Seismic Walkdown Checklist (SWC)

Equipment ID No. 1-2403-64-001-V02 Equip. Class¹² Z1 - Tanks and Heat Exchangers
~~H7 - Engine Generators~~ W.S. 8/28/12

Equipment Description DG AIR START RECEIVER

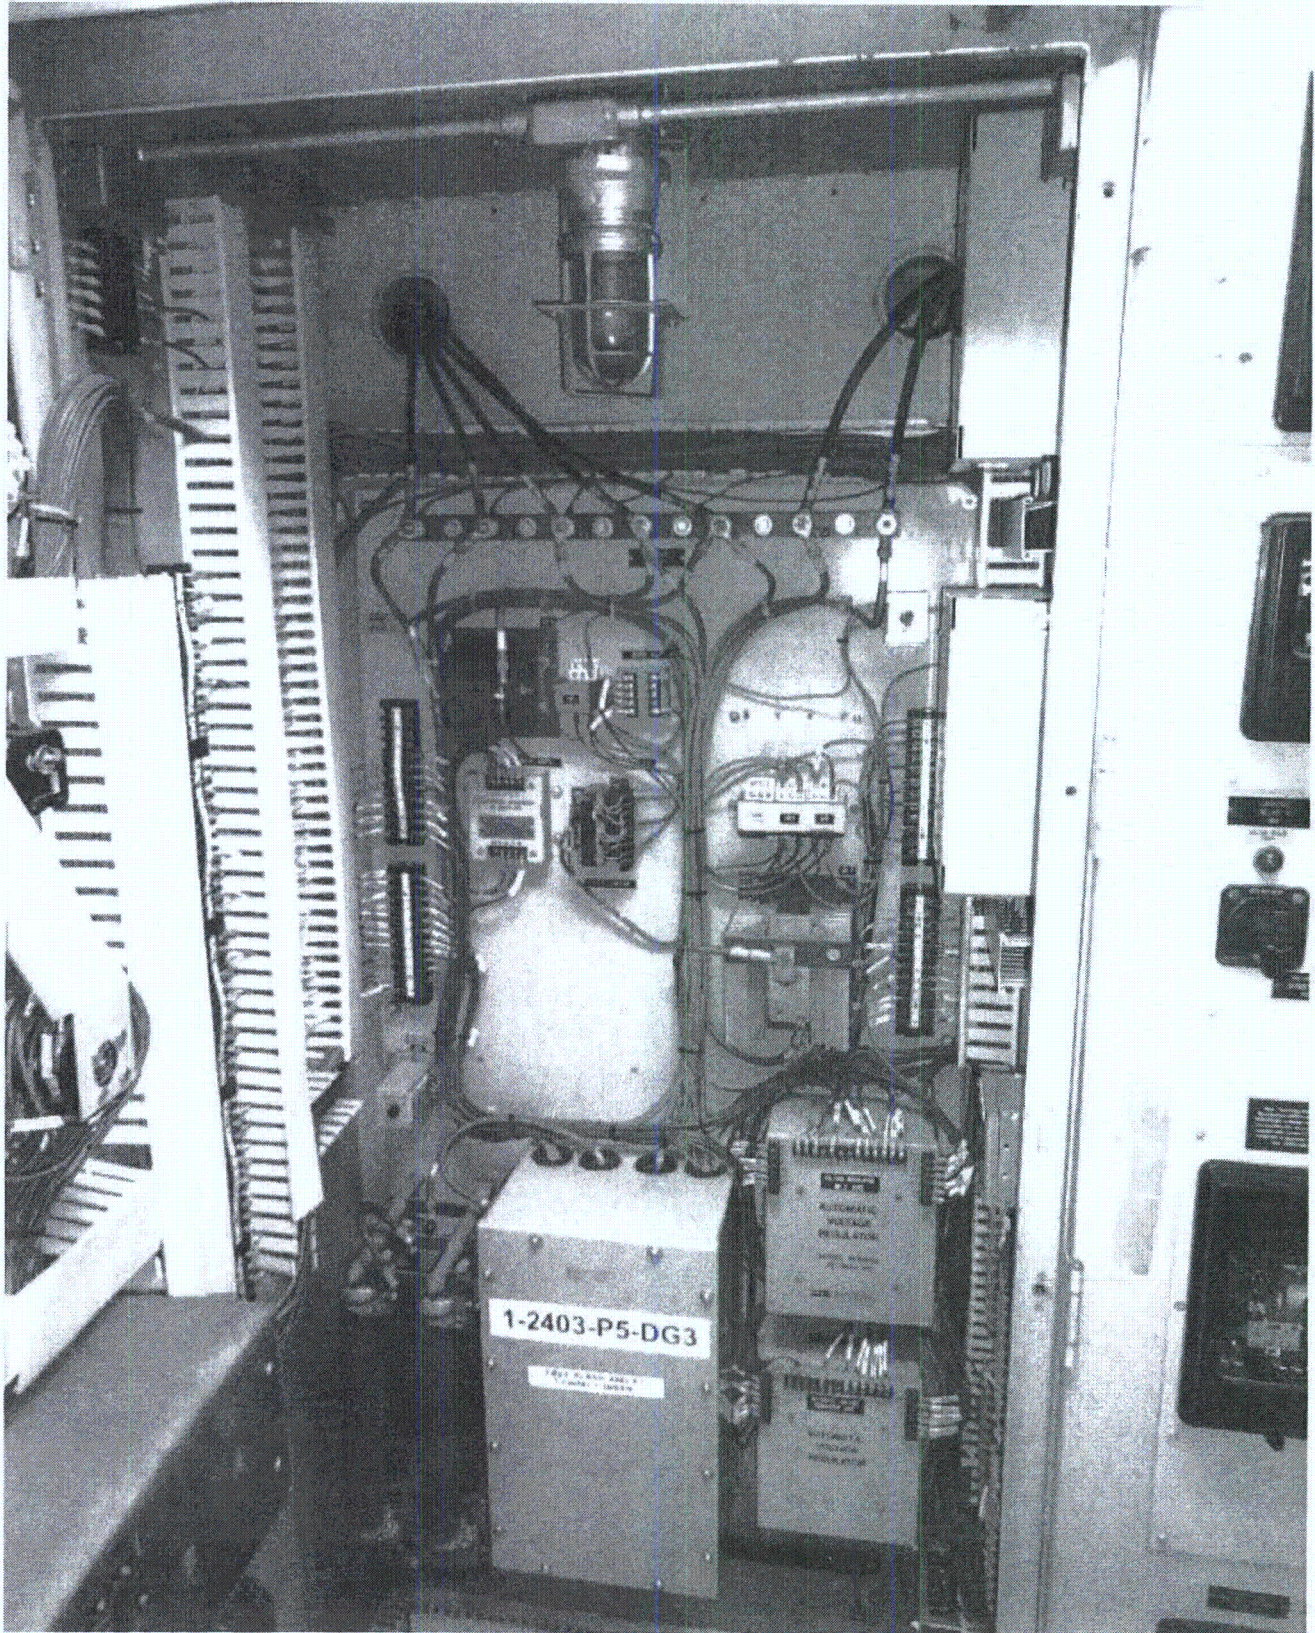
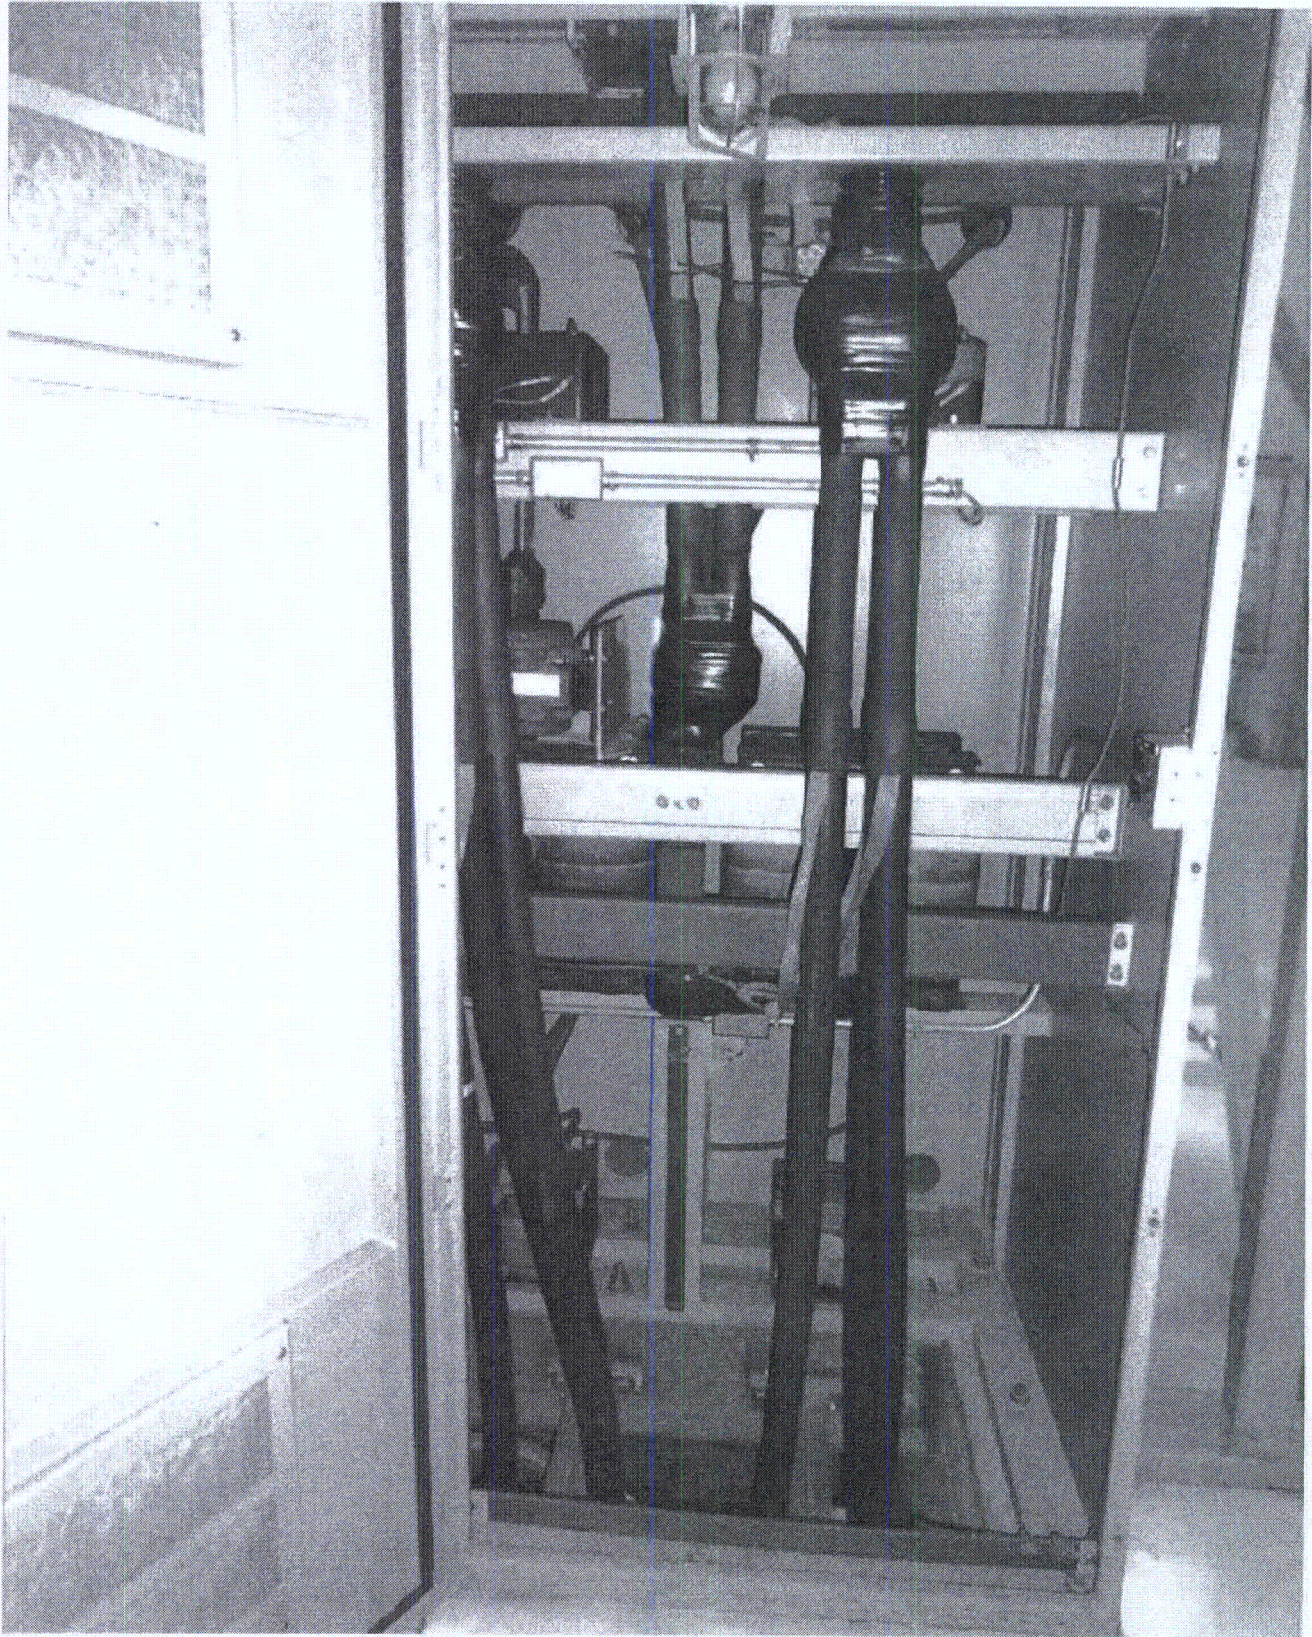
Found screws missing used to secure ventilation panel door window and a cover plate. It was judged that this condition does not represent a seismic vulnerability or concern. Reference condition report 528369

Equipment ID No. 1-2403-T4-004 Equip. Class¹² 21 (Tanks FITX)

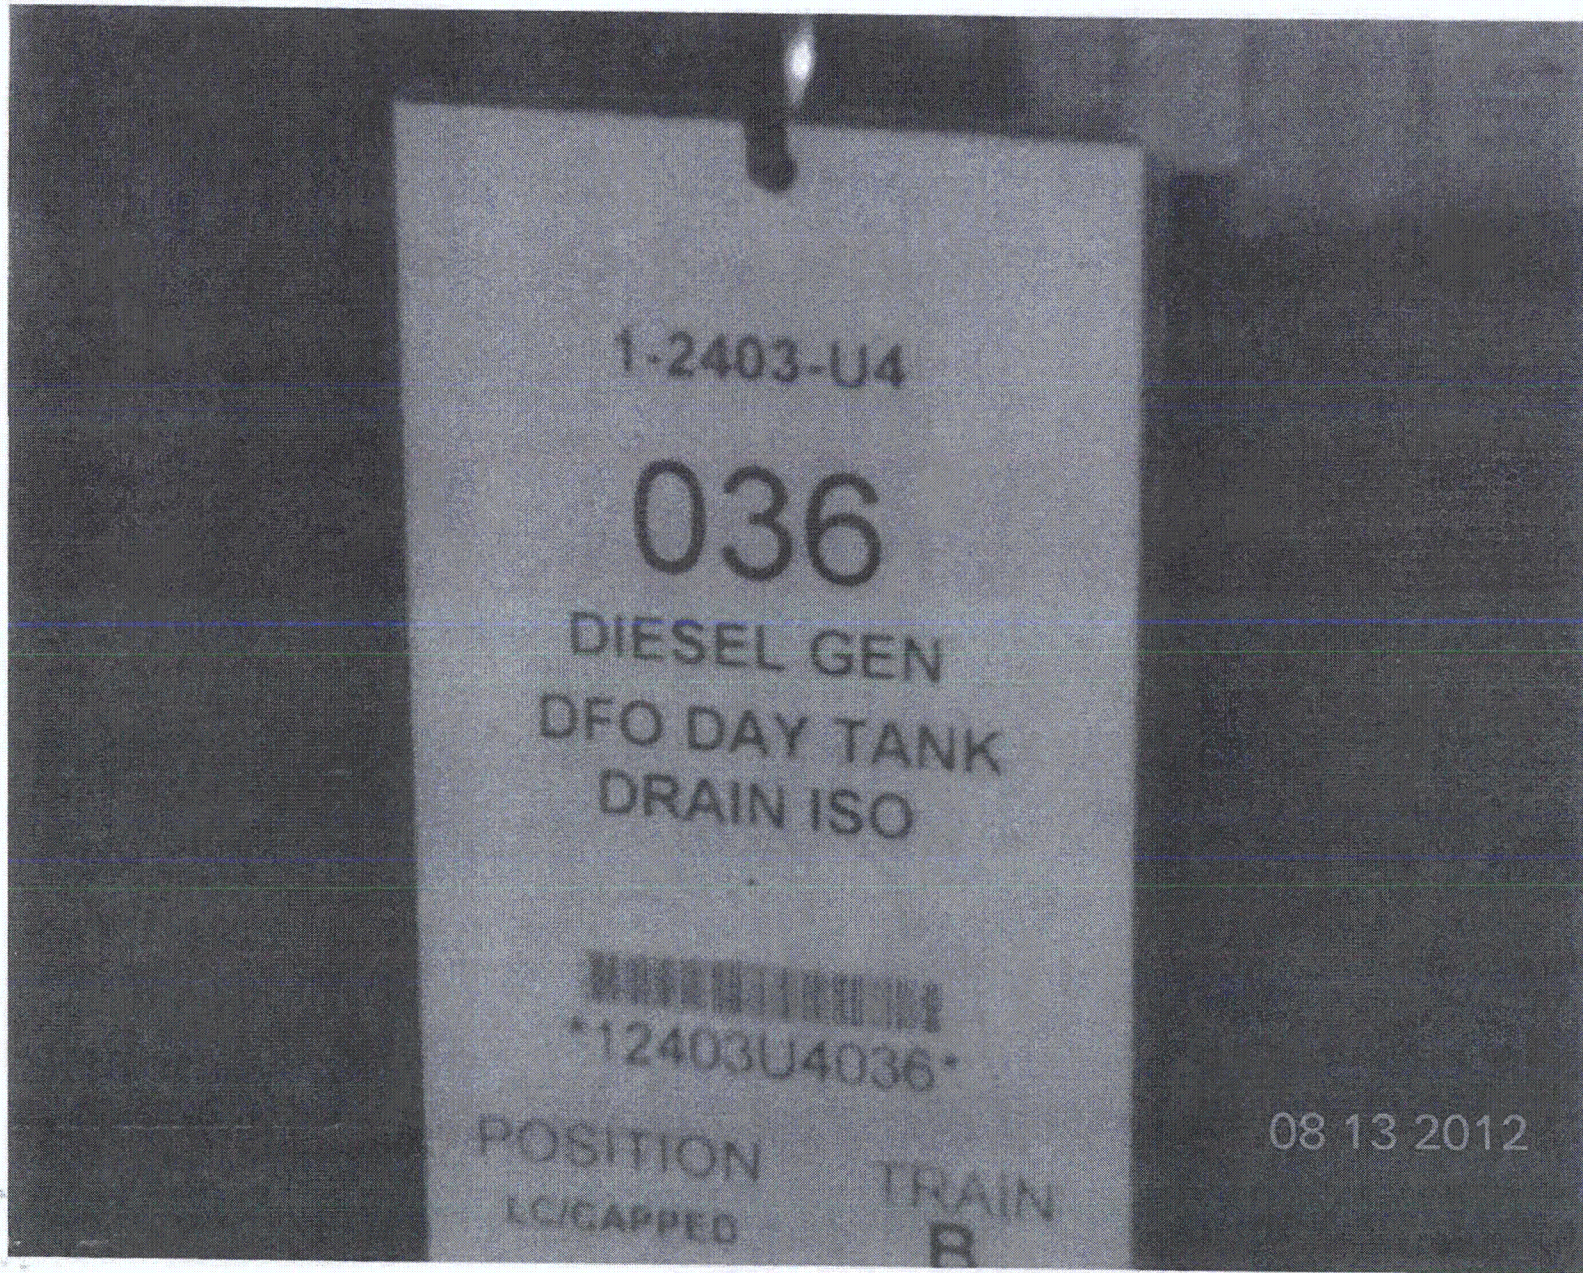
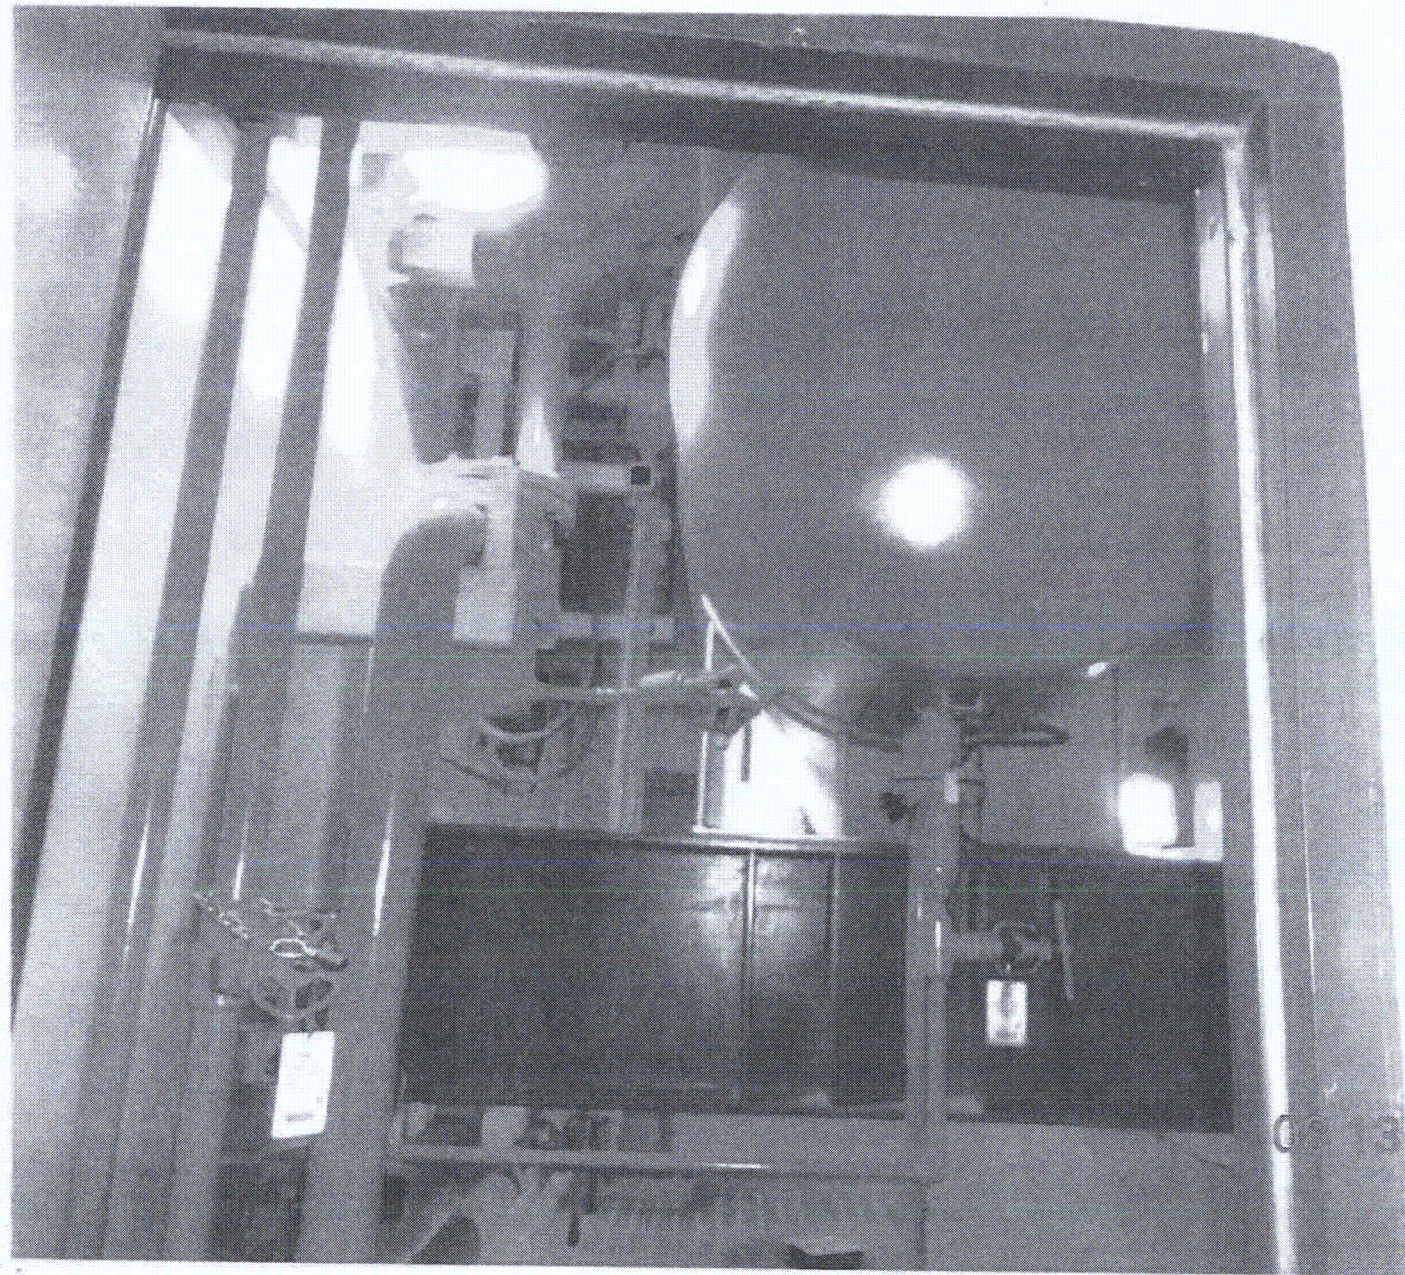
4. Is the anchorage free of visible cracks in the concrete near the anchors? Y N U N/A
Anchors are threaded studs to structural WF beam with double nuts above supp't saddle.

6. Based on the above anchorage evaluations, is the anchorage free of potentially adverse seismic conditions? Y N U
All gaps are 1/4" max between saddle & WF beam; judged to be acceptable since shim is direct load to WF beam, where stiffeners are provided.

*flexible conduits attached to area equipment
large bore piping rigidly supported and attached to tank; thus no differential movement expected*
